Proposal to amend gtr7 annex4

Backset measurement test procedure using HRMD method

CLEPA/OICA Proposal
19th march 2012 GTR7 phase II inf

2. Definition of tolerances for relevant dimensions

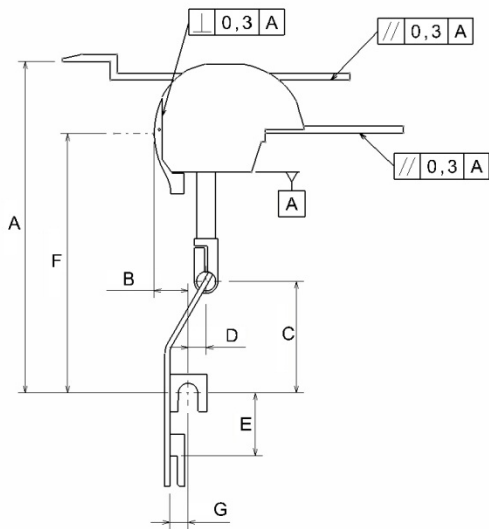
- current text in gtr 7 annex 4:
 - dimensions of HRMD described in table of figure 4-1, but tolerances missing
 - dimensions (including tolerances) of HPM in combination with HRMD missing
- reliable test tools guarantee reproducible and repeatable test results
- accumulating of tolerances shall be avoided
- tolerances of test tool must be smaller than tolerances for backset criteria

Dimension	Tolerance
A	Distance between weight hangers and Z-probe	441.0 mm	[±0.5 mm]
B	Distance between weight hangers and backset probe	48.0 mm	[±0.3 mm]
C	Distance between weight hangers and HRMD axis in Z	148.0 mm	[±0.5 mm]
D	Distance between weight hangers and HRMD axis in X	23.0 mm	[±0.3 mm]
E	maximal distance of weight hanger adapter to HPM hook	< 101.5 mm	
F	Distance between the apex of X-probe and the H-Point axis	333.5 mm	[±0.5 mm]
G	Distance between weight hangers and contact surface	25.0 mm	[±0.3 mm]
